ROL13 – Precincts 5, 6 & 7 Everleigh

ENGINEERING SERVICES REPORT

Report No: MIR-1300/R2403580

AMENDED IN RED

MIRVAC QLD PTY LTD **EVERLEIGH ROL13 SUBDIVISION DEVELOPMENT** TEVIOT ROAD, GREENBANK TYPICAL ROAD CROSS SECTIONS

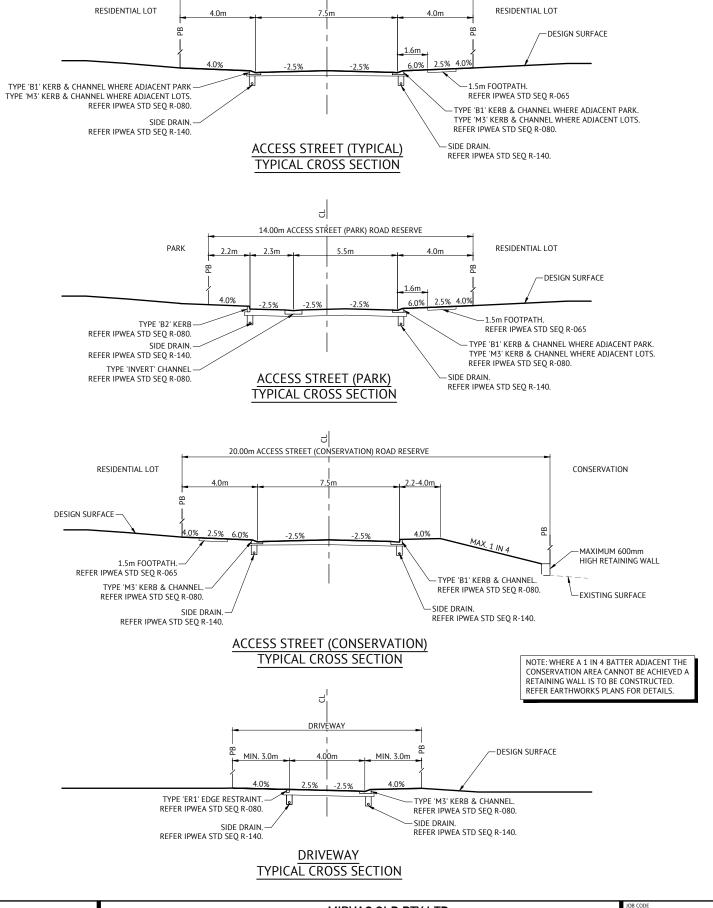
Guroman Drive cross section to be designed to accommodate indented bus bays in accordance with the conditions of approval DEV2024/1517 and DTMR Road Planning and Design Manual
